WATERLOO METRO QUARTER OVER STATION DEVELOPMENT- CENTRAL PRECINCT DETAILED DESIGN SSD-10439

Response to Submissions

Figure 1 Botany Road DDA Access Route

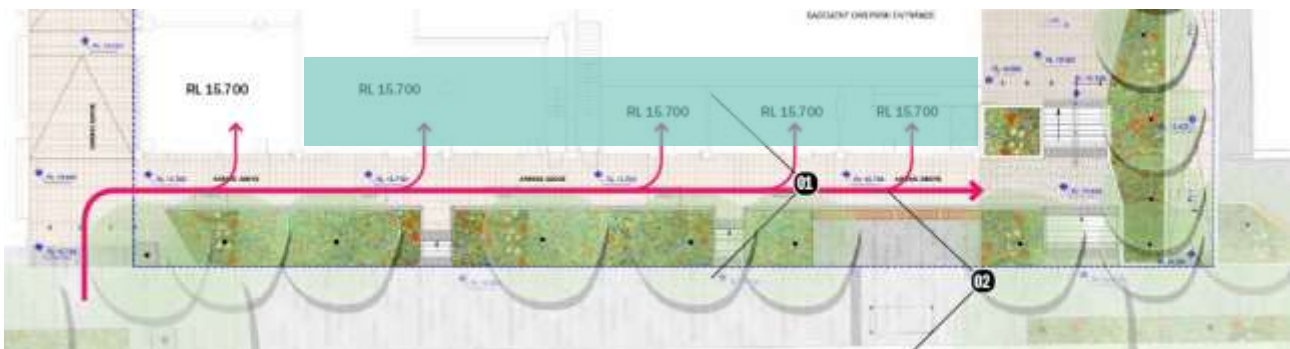
Design changes are proposed to the ground floor of the Central Building in order to comply with 1% Annual Exceedance Probability (**AEP**) flood level along Botany Road. The design change includes raising the floor level of the building located along the southern portion of Botany Road (area highlighted in blue on Figure 1) to 15.70m AHD.

Equitable access into the retail area is achieved from the northern end of Botany Road, adjacent to Grit Lane, where a gradual change in RL (RL 15.75 to RL 15.7) is provided (refer to Figure 1).

Figure 3 Proposed Childcare Centre Area Breakdown

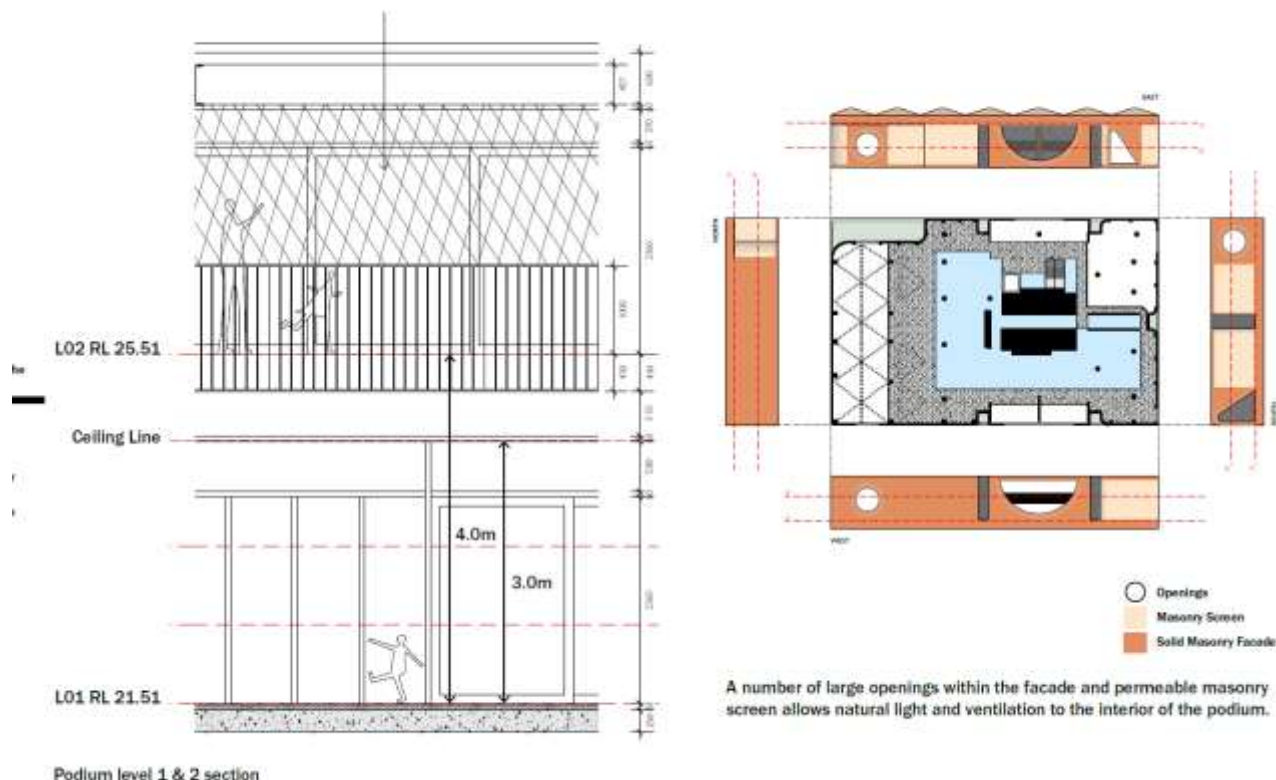
Childcare by Design has prepared a response letter (attached at Appendix U) which assesses the internal areas of the proposed childcare centre. It concludes that the floorplate can sufficiently provide for the needs of 146 children and associated staff.

As shown in Figure 3 and the area summary table prepared by Childcare by Design, the proposed floorplate allows for 146 children aged 0 – 5 years to be grouped in designated rooms over two podium levels, which is consistent with *Education and Care Services National Regulations (Childcare Regulations)*.

Figure 5 Site Constraints

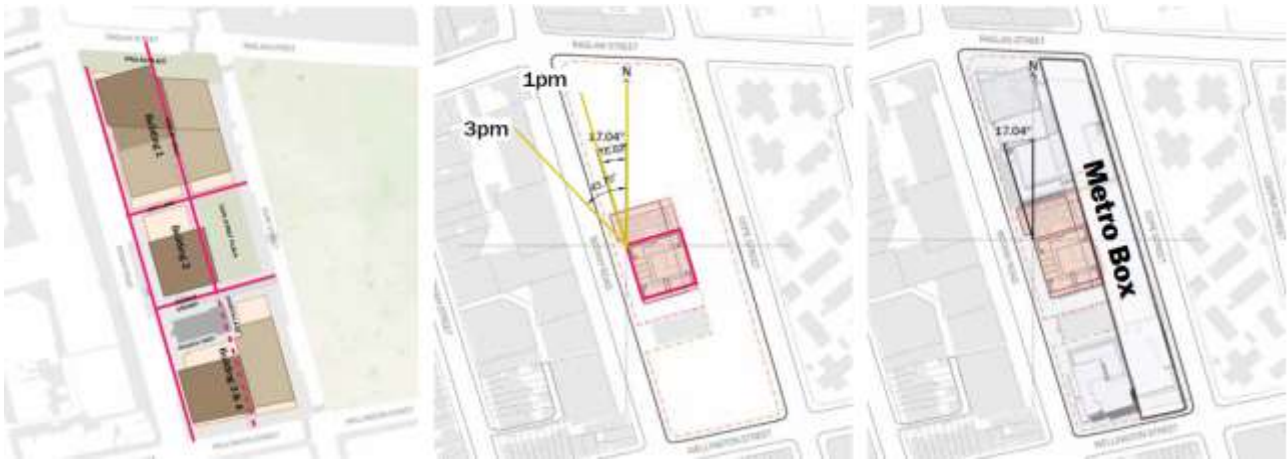
Justification for the design response to the ADG design criteria for solar access is discussed below and provided in the Supplementary Design Report (attached at Appendix B).

The site is constrained in its ability to achieve solar access in mid-winter in the following ways (refer to Figure 5):

Figure 6 Apartment layout test

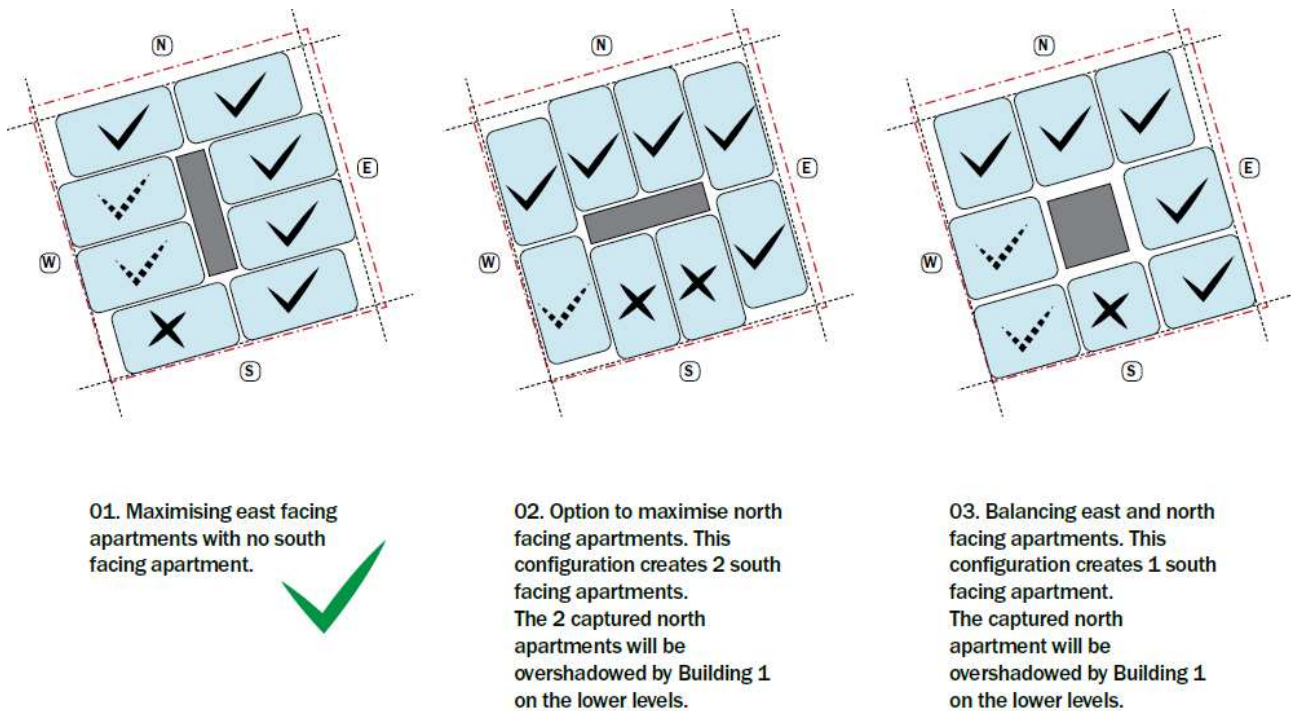
Considering the site constraints outlined above, the proposal reduced the overall Concept SSD building height of the Central Building and Building 1 on the Northern Precinct (as outlined in the RtS for SSD-10440), to improve solar access for the site.

Following the review of building rotation, different apartment layout and configurations were explored by the design team to maximise east and north facing apartments, while minimising south facing apartments within the envelope (refer to Figure 6).

Figure 7 Design options to test solar compliance

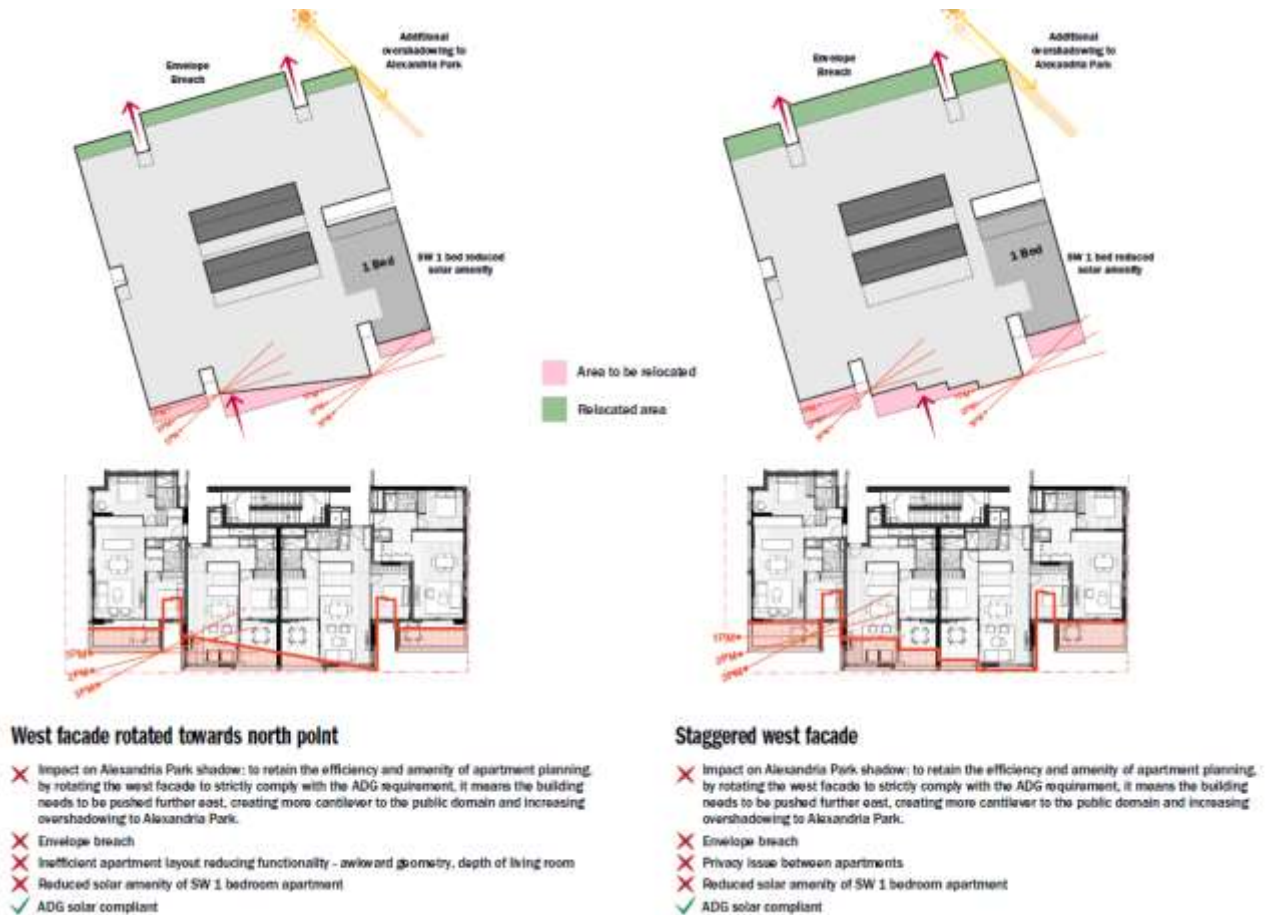
In addition to apartment configuration, a number of design options were explored to test the implications of strictly complying with the solar guideline under the ADG.

This design options include (refer to Figure 7):

Figure 9 Central building retail tenancies basement access routes

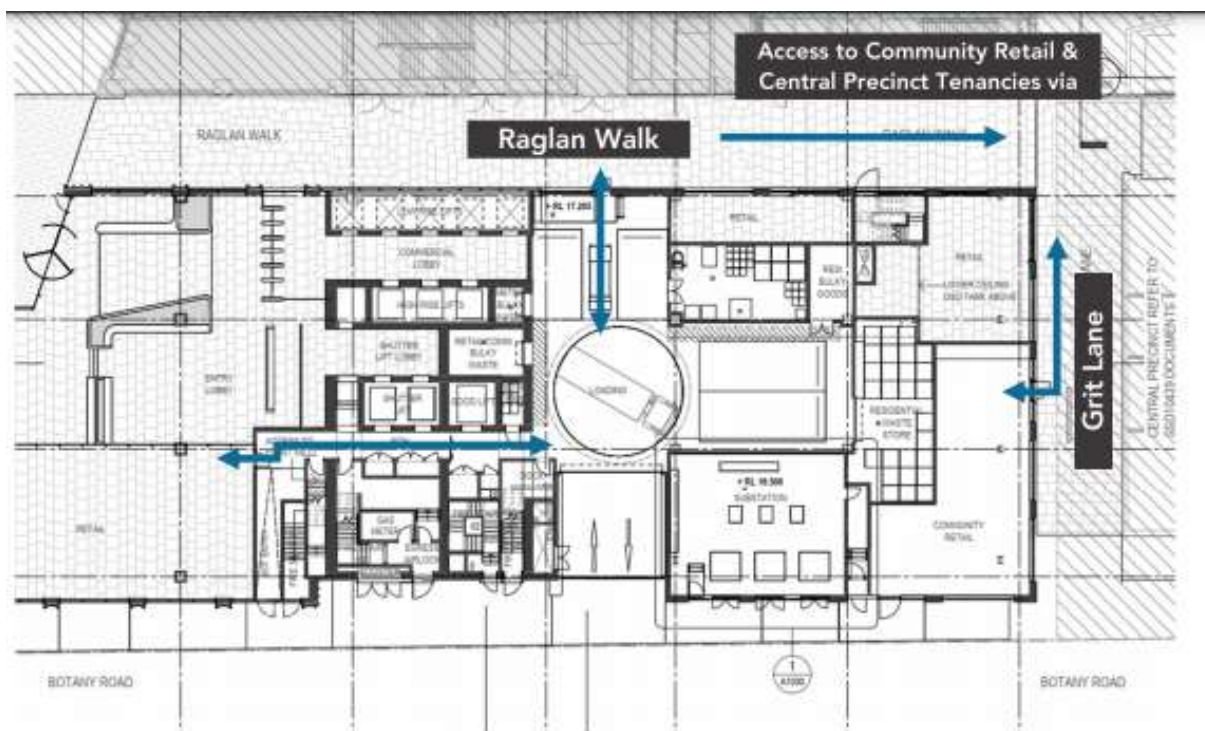
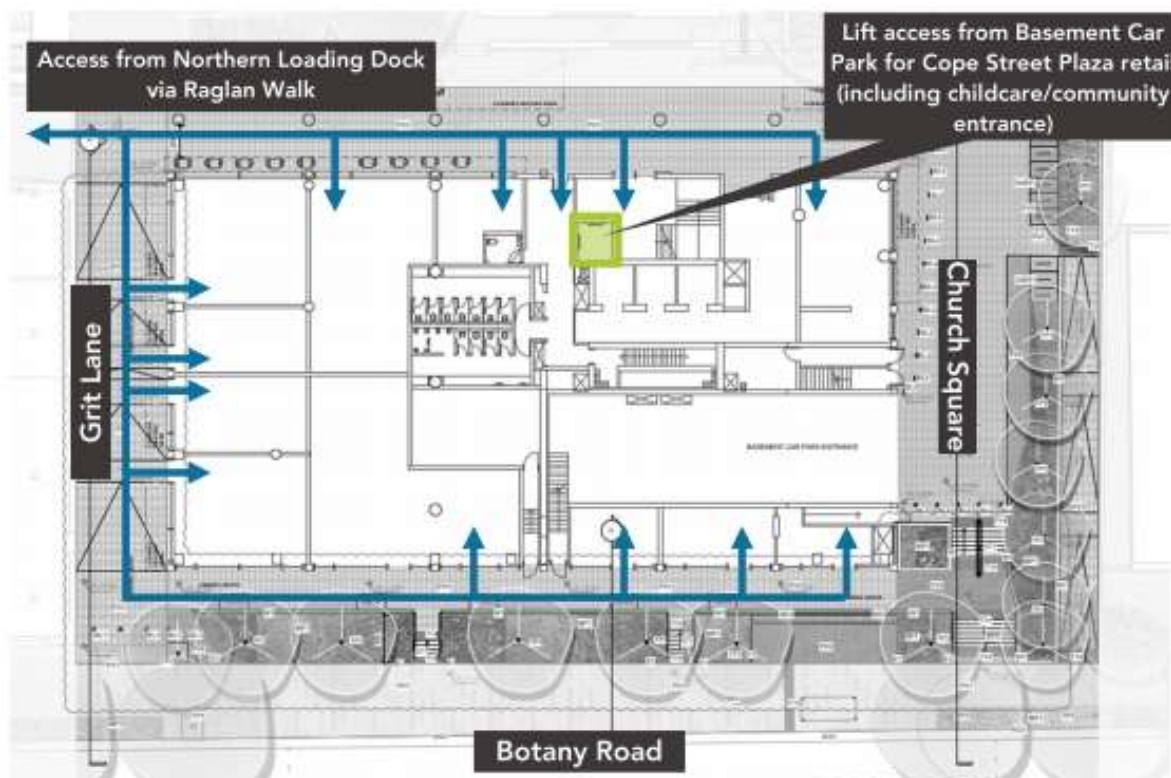
Central building retail tenancies are able to access the Northern Precinct basement for services and loading via the routes outlined in Figure 8 below.

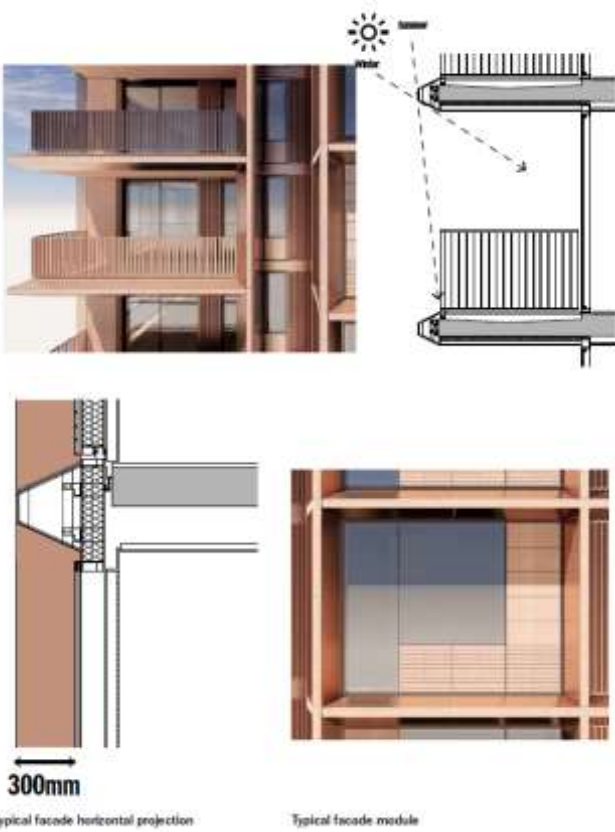
Comment	Response
	<p><i>improvement to wind mitigation does not outweigh the impediment they may create to wayfinding, accessibility and solar access.”</i></p> <p>Section 3G</p> <p>The inclusion of awning elements and street tree planting noted in the landscape plan results in the entire bus stop zone as well as the pedestrian crossing areas satisfying the standing criteria as outlined in the WMQ Design Guidelines. Furthermore, areas for the bus stop waiting zone will also satisfy the sitting criteria conditions.</p>
<p>13. Awnings – all awnings located over the public domain and through-site links are to be between 3.2m and 4.2m above finished ground level and to be setback a minimum 800mm from the kerb. Awning widths are to be between 2 metres and 3.6 metres whilst remaining clear of smartpoles by 1 metre and street trees by 1.5 metres.</p>	<p>The ground floor of the Central Building incorporates a variety of awning types to provide shelter in front of building entries. The variety of awning types is consistent with the Urban Design principles for the precinct.</p> <p>Sections showing awning details and type are included in the Supplementary Design Report prepared by Hassell and attached at Appendix B.</p> <p>The following awning types are proposed (refer to Figure 9):</p> <ul style="list-style-type: none"> ▪ Type A awning: 2m deep localised awnings are provided along Grit Lane. ▪ Type B awning: a 2.5m deep continuous glazed aluminium awning is provided along Botany Road. To provide protection for pedestrians and retail tenancy users, as well as providing weather protection for people waiting for buses. ▪ Type C awning: the podium above projects beyond the ground floor facade by 5.7m. Providing weather protection for pedestrians and outdoor seating zones, as well as residential and childcare entries. ▪ Type D awning: the podium above projects beyond the ground floor facade by 2.9m. Providing weather protection for pedestrians and parking entry.

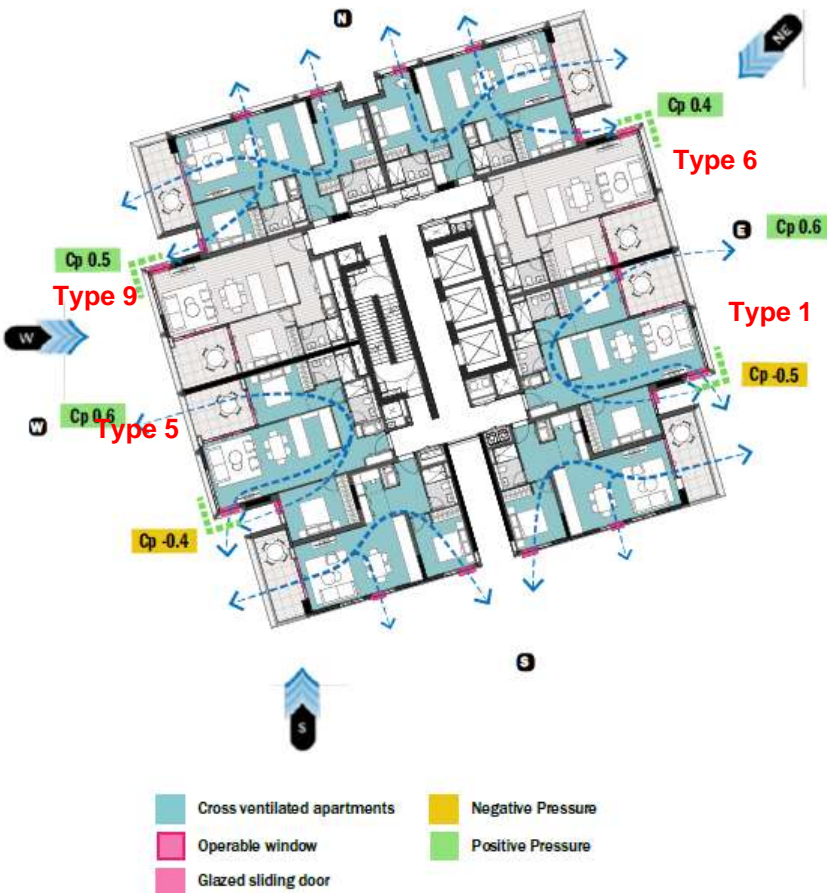
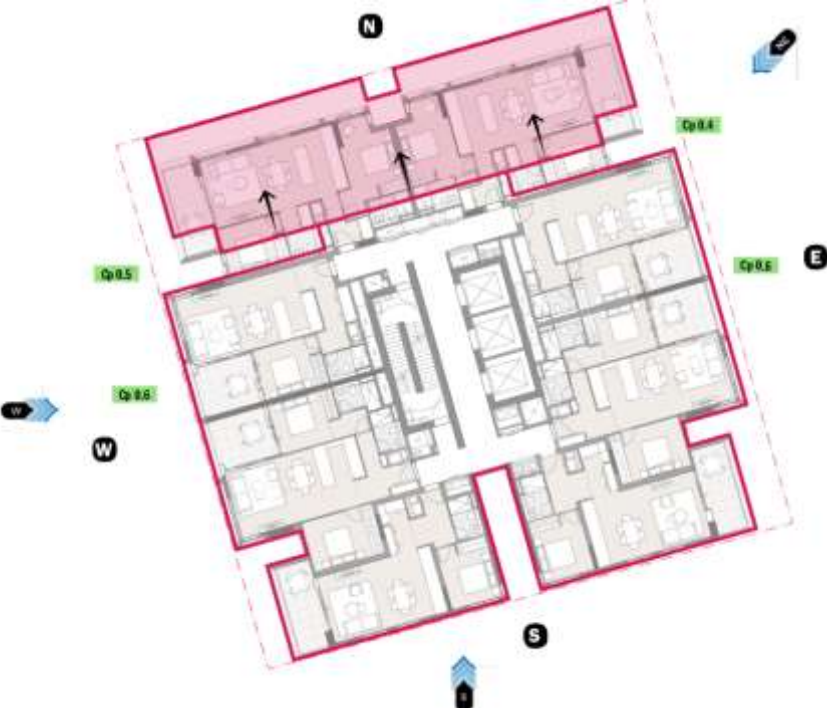
19. External sun shading – contrary to Objective 4A-3 of the ADG. Despite probable compliance with internal thermal targets via energy rating tools, the tower facade design does not provide residents with the means to passively shade and cool their	A technical memo has been prepared by Cundall and submitted at Appendix O. The memo addresses the effectiveness of the proposed

Comment	Response
	<ul style="list-style-type: none"> ▪ The setback notch on the western façade also divert sunlight in summer. ▪ The facade grid projects 300mm over the façade. Horizontal and vertical solid panels are also provided, which provide shading to the glazed area of the façade. ▪ Aluminium framed double glazing (high VLT, low reflectivity) is proposed to all units, except for sliding doors and operable windows. Performance glazing is proposed to reduce heat gains in addition to passive shading. ▪ Apartments on the north and west elevation will be fitted with internal blinds, which will further assist with shading. <p>On average, the portion of the façade without balcony or setbacks is 56% solid. The solid to glazed ratio provides balanced amenity for solar, privacy, sunlight and views. While the balconies and notch provide passive shading to 75% of the western elevation.</p> <p>Therefore, the proposed façade design is able to achieve thermal comfort without incorporating external shading devices.</p>
